METROPOLITAN GOVERNMENT OF NASHVILLE AND DAVIDSON COUNTY

STAFF RECOMMENDATION
1807 Beechwood Avenue
September 16, 2015

Application: New construction—addition
District: Belmont-Hillsboro Neighborhood Conservation Zoning Overlay
Council District: 18
Map and Parcel Number: 10416025500
Applicant: Stone Oak Builders
Project Lead: Melissa Baldock, melissa.baldock@nashville.gov

<p>Description of Project: Application is to construct a rear addition that is taller than the historic structure.</p> <p>Recommendation Summary: Staff recommends approval of the project with the following conditions:</p> <ol style="list-style-type: none"> 1. Staff approve the final details, dimensions and materials of windows and doors prior to purchase and installation; 2. Staff approve the shingle and metal roof colors, dimensions and textures; and 3. The HVAC shall be located behind the house or on either side, beyond the mid-point of the house. <p>With these conditions, staff finds that the project meets Sections II.B. and V.B. of the <i>Belmont-Hillsboro Neighborhood Conservation Zoning Overlay: Handbook and Design Guidelines</i>.</p>	<p>Attachments A: Photographs B: Site Plan D: Elevations</p>
---	--

Figure 2. The window that is to be enlarged.

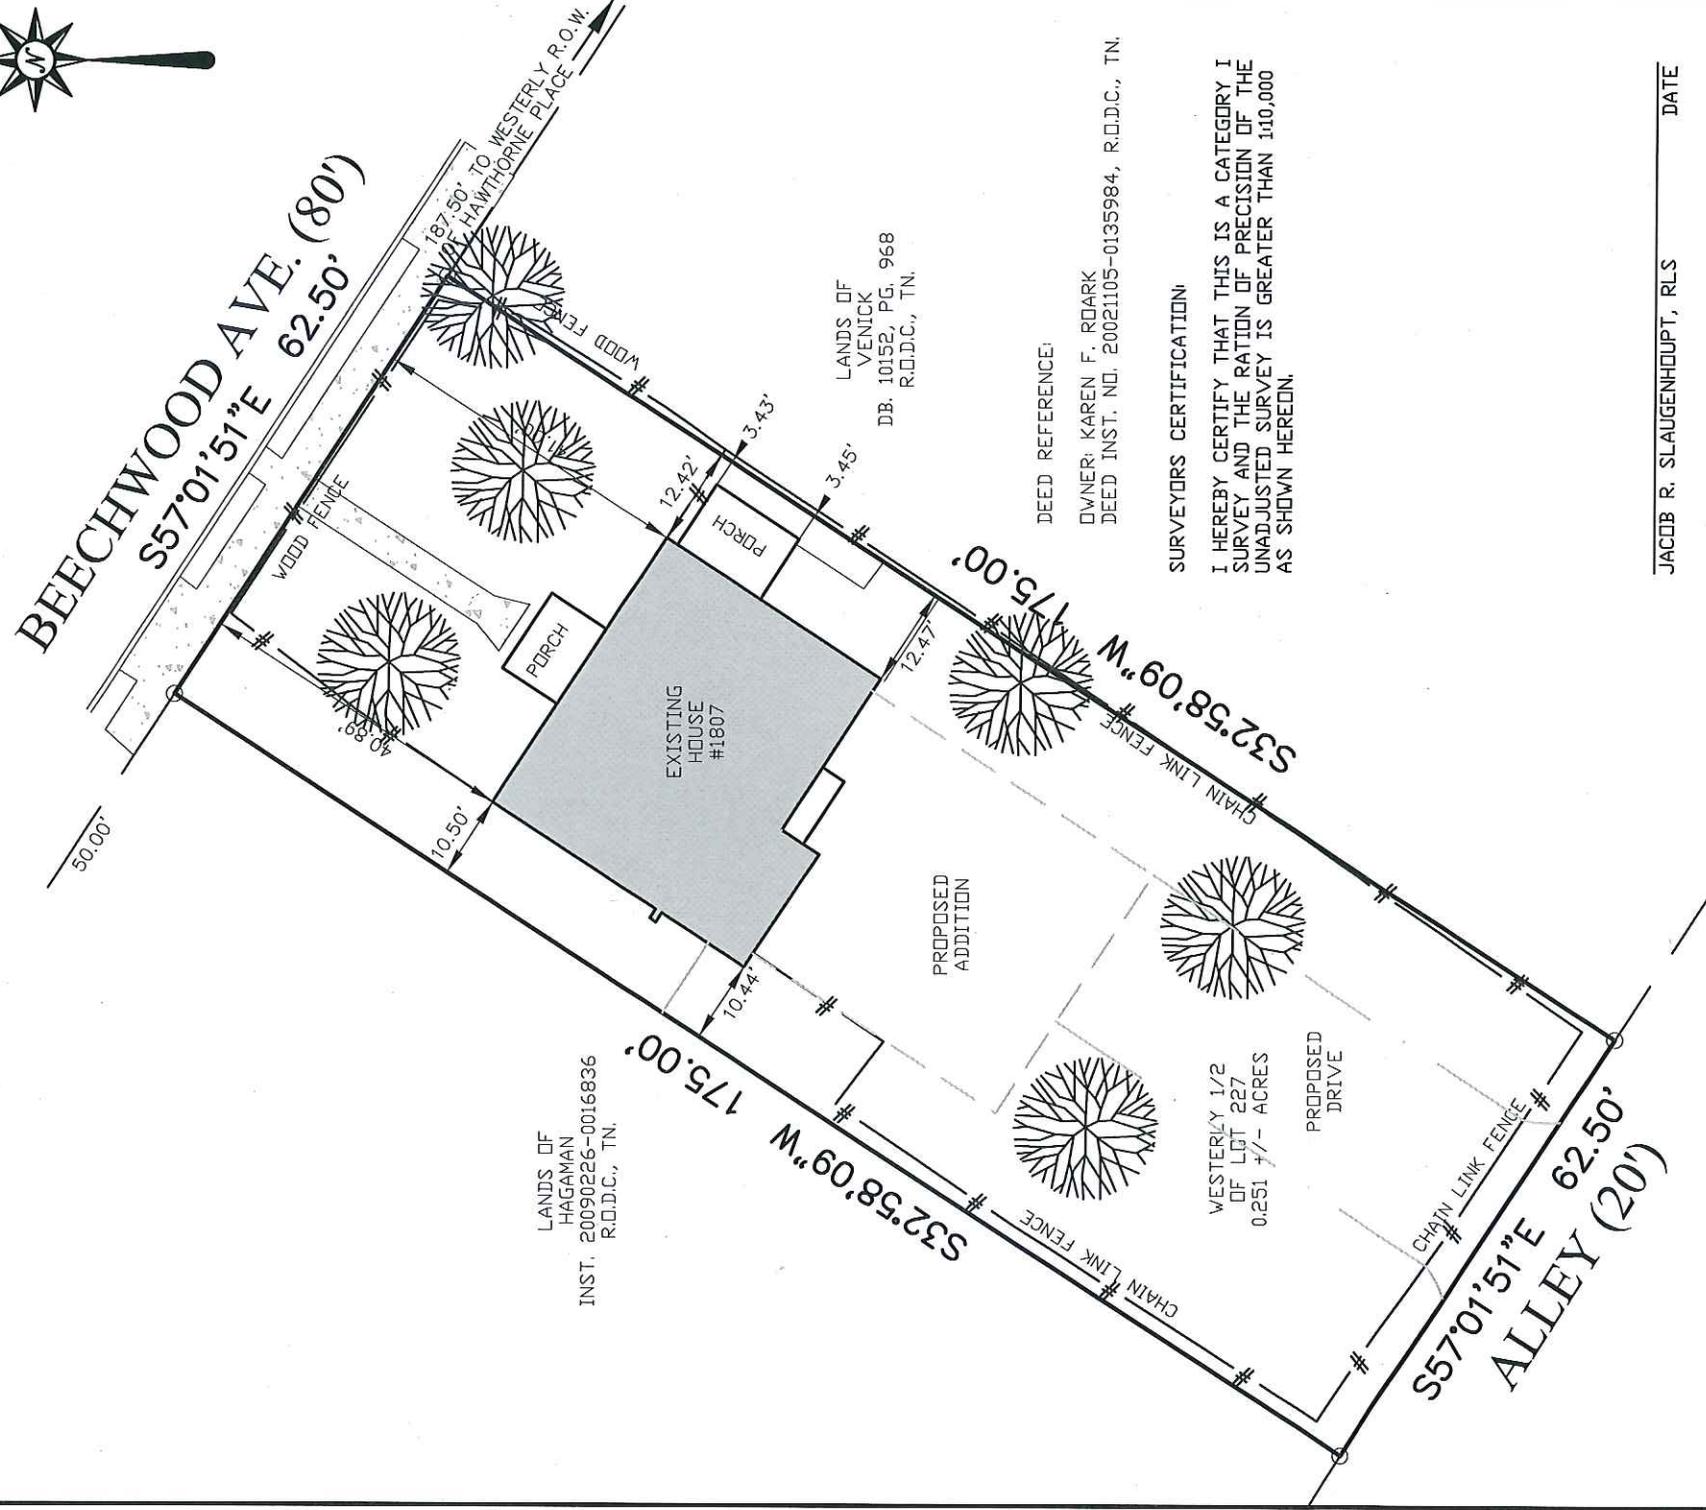
Partial Demolition: The applicant proposes enlarge one window opening on the left façade of the historic house, and the Commission considers this to be partial demolition (Figure 2). Staff finds the window alteration to be appropriate in this instance because the window opening is on a side façade, behind the side porch, and beyond the midpoint of the house. The window opening is minimally visible from the street, but its enlargement will not adversely impact the historic character of the house. The drawings show that all of the other windows openings will remain unaltered. Staff finds that the proposed alteration of the window opening on the left side facade meets Section V.2. for appropriate demolition and does not meet Section V.1. for inappropriate demolition.

PROPOSED FRONT ELEVATION

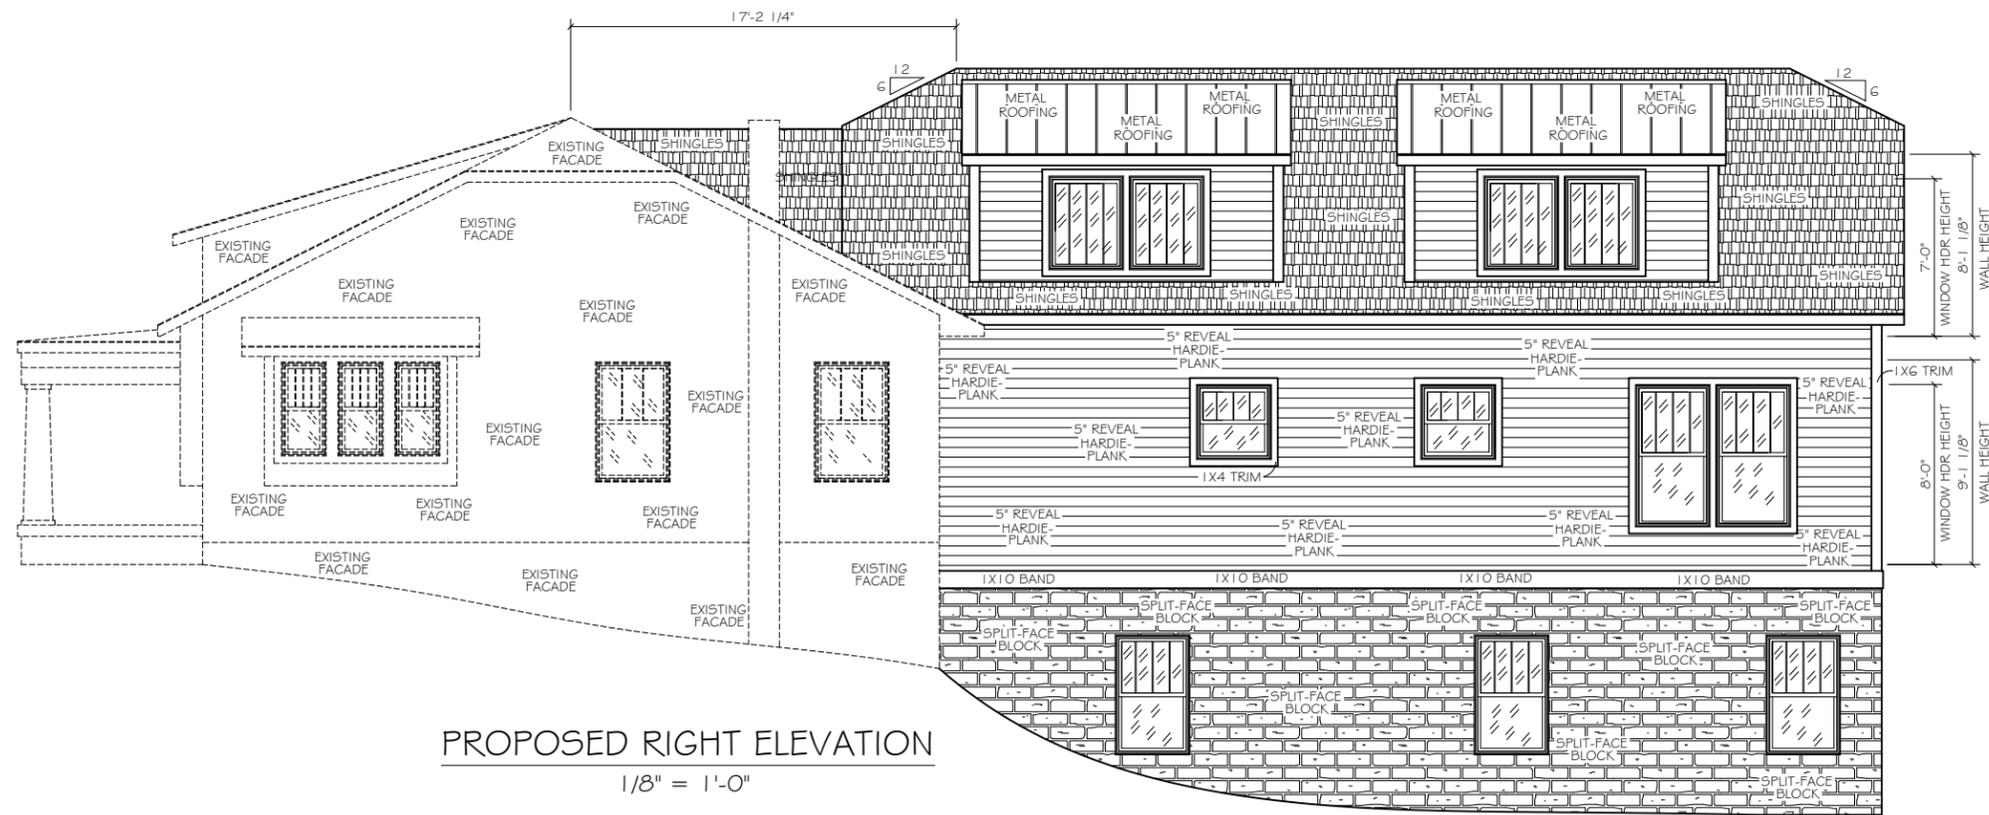
Height & Scale: The proposed addition is located entirely behind the historic house. The addition will be approximately two feet (2') taller than the historic house at a point more than forty feet (40') from the front of the house. The taller portion of the addition will have a clipped gable roof to help minimize its visibility from the street. The eave heights

Roof form: The roof of the addition ties into the historic house's roof at a point six inches (6") below the ridge, which is appropriate. The addition's primary roof form is a clipped gable with a 7/12 pitch. The side elevations include shed dormers that are set off the roof ridge and are set off the wall below. The left side elevation includes a wall dormer for an interior stairwell. The Commission traditionally has found that wall dormers do not meet the design guidelines. Staff, however, finds this wall dormer to be appropriate because it is located over fifty feet (50') from the front of the house. Also the addition at this point is inset two feet (2') from the back wall of the house, and is further obscured by an open side porch that extends approximately nine feet (9') from the house

PROPOSED LEFT ELEVATION

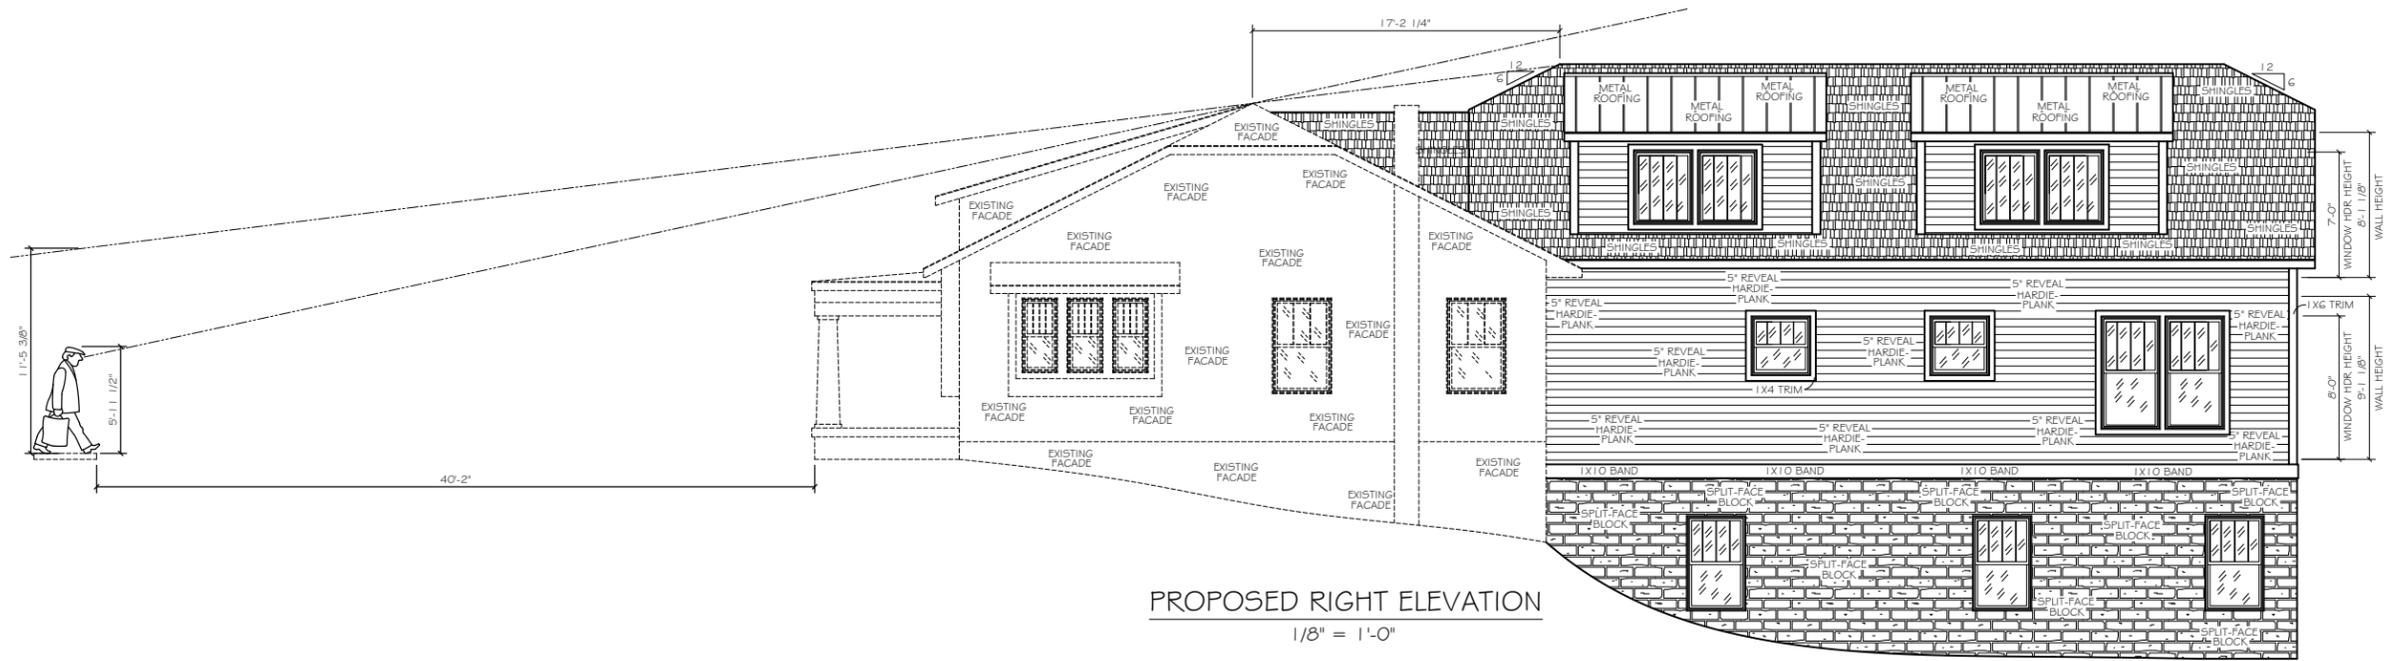
on the left façade. The visibility of the wall dormer will be minimal. Staff therefore finds that the proposed roof forms meet Sections II.B.1.e. of the design guidelines.
